From: Marie C. Boucher
To: Jim Sullivan
Cc: Sullivan, Jim (OAH); janezich, Craig (DNR)
Subject: Discrepancies in Great River Energy Route Requests E015 OAH Docket No 21-2500-39822 attachment D. Attn: Will Seuffert
Date: Sunday, November 17, 2024 2:59:40 PM
Attachments: [Redacted]

From: "Marie C. Boucher" <mboucher.pers@icloud.com>
Date: November 10, 2024 at 4:36:11 PM CST
To: Jim Sullivan <jim.sullivan@state.mn.us>; craig.janezich@state.mn.us
Subject: Discrepancies in Great River Energy Route Requests E015 OAH Docket No 21-2500-39822 attachment D

MODIFIED PROPOSED ROUTE Northland Reliability Project

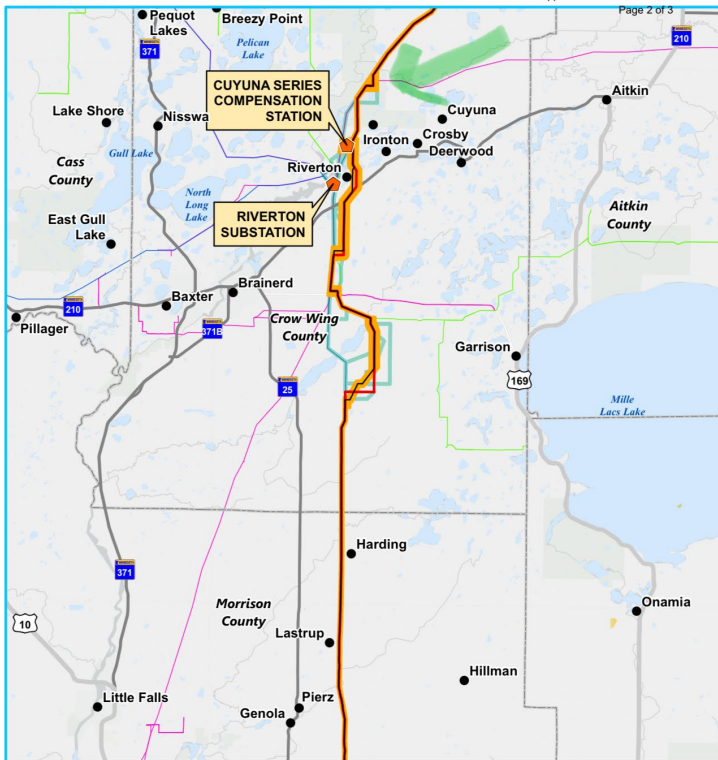
The applicant's final request Docket 22-415 20249-210355 dated 9-19-2024 contradicts that. See their two maps attached.

It's the applicant's Co-location map that includes the AA3 (keeping it along the existing ROW) not their Modified proposed map (which still has it diverting off the main transmission line ROW through our property and neighborhood). Even though they say it's not a preferred route!

In one sentence they say they are proposing the Co-location maximization route, yet on the other hand they are wanting their Modified Proposed Route approved as if they are one in the same.

If the applicant is seriously planning to proceed with the Co-location Maximization Route in the Cole Lake region, why are they requesting a one mile route ROW?

If the applicant is seriously planning to proceed with the Co-location Maximization Route in the Cole Lake region, why are they needing expanded route width?

The applicants states for flexibility to avoid impact on residence and landowner comments. If it stayed on the existing ROW with Co-location, there would be no need for any additional route width.
